**APPROVED  
MINUTES OF THE MEETING**

**September 17, 2009**

<b>September 17, 2009 Project:</b>	<b>Rainier Beach Community Center</b>
<b>Phase:</b>	Concept Design
<b>Last Reviewed:</b>	N/A
<b>Presenters:</b>	David Graves, Department of Parks and Recreation Stan Lokting, ARC Architects Dave Rutherford, ARC Architects
<b>Attendees:</b>	David Sauvion, Rainier Beach Public Advisory Team (PAT) Emily Wheeler, ARC Jason Huff, Office of Arts and Cultural Affairs Michael Shiosaki, Department of Parks and Recreation Paul Curtis, ARC

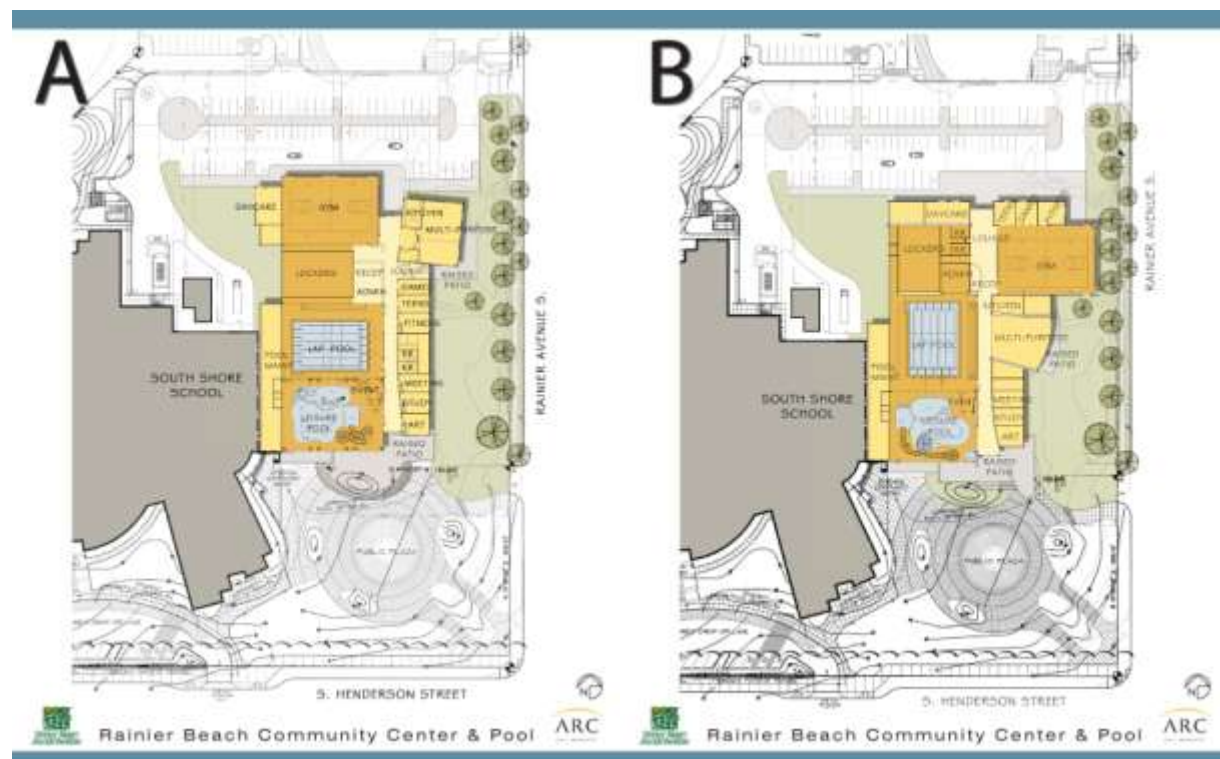
*I don't have a clear concept between the relationship between the school and community center. The reasons you are joining them together are good, but you need rigor. I'm not seeing the clarity in B and C, but more so in A.*

*In A, the lawn seems big. It needs to be an active and dynamic use.*

*The patio's connection to the plaza seems so indeterminate and unresolved. It doesn't feel generous. Anything that we can do to encourage pedestrians and biking would be great. We need to emphasize the Henderson Street entrance for that reason. The outdoor spaces need connection back into the building and programming.*

We agree. We think we could bring the clarity to C that we have in A.

Yes. We're thinking it is defensible space, like the lawn at Northgate.

We don't own the plaza. The school district does. We're negotiating with the school district what the boundaries are with the site.

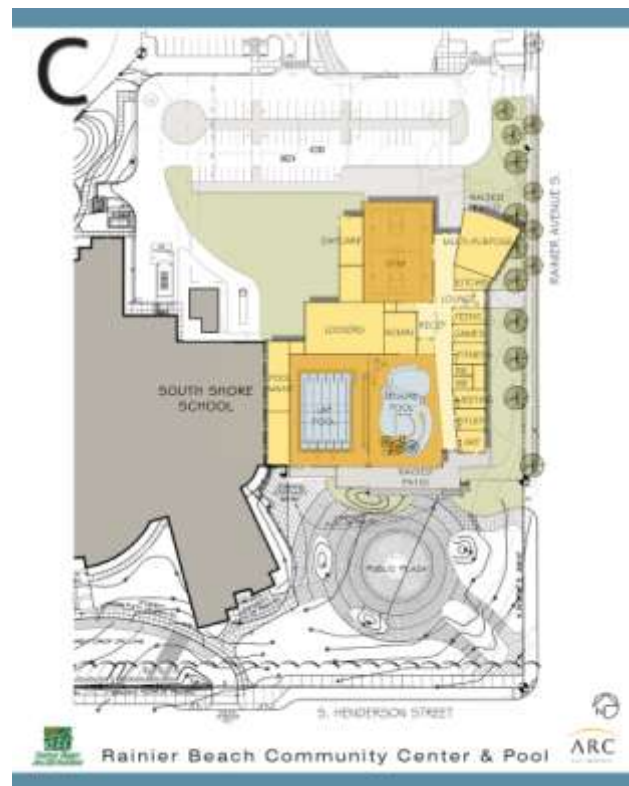
*Why is the pool always at the south end?*

*How do people arrive by foot? What's your front door?*

Leisure pools are best when south facing. The gym is located toward the north for natural ventilation and connections to the lot for outdoor use.

85% drive large cars. We hope light rail will change that. The door to the north near the parking lot will be used most often, most likely. We like to have the reception area close to this door.
